Planning, Land Use and Mobility Committee

CASE REPORT (R2)

CPC-2022-8820-2C/CU/ZV/SPE-SPP-SPR

Extra Space Storage Facility
20401 Ventura Blvd.
Woodland Hills, 91364

Elevation of North side of project overlooking 101 Freeway and showing slight height articulations, “faux window” treatment and various fascia materials.

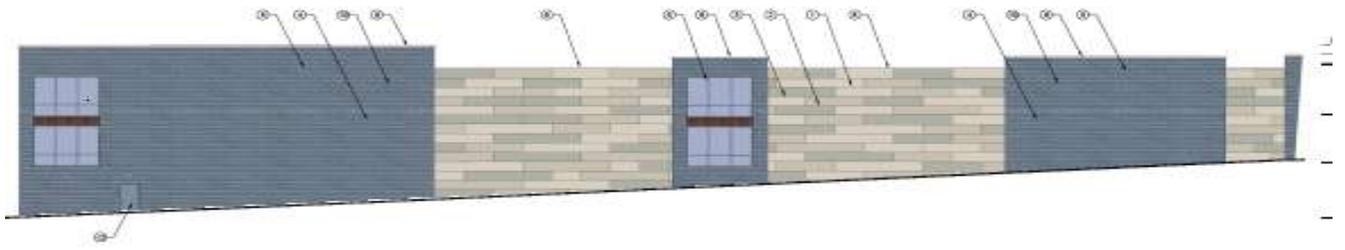
The most significant improvement to the overall design was the modifications made to the North facade that runs the length of the property along the 101 Freeway, and will be seen from the residences across the freeway. While still not as architecturally interesting as the other three facades, it is a substantial step up from the blank white “wall” that was originally proposed.

Reconsidering the north-facing façade overlooking the 101 Freeway to make more architecturally interesting also received a large measure of support.

- There was concern from a stakeholder and two PLUM members about the view of the project from across the freeway. They questioned if they could see a perspective from across the freeway that more accurately showed the view that homeowners there would have. They also asked if a row of trees or high-growing shrubs be planted along the north property border in case CalTrans removed or reduced any of the existing trees/shrubs on that side of the 101 in the future.

- 5.) A row of tall-growing deciduous trees (minimum 24” boxes) or high-growing shrubs such as Carolina Cherry Laurel shall be planted along the northern boundary overlooking the 101 Freeway to shield the structure from viewing by residents across the Freeway.
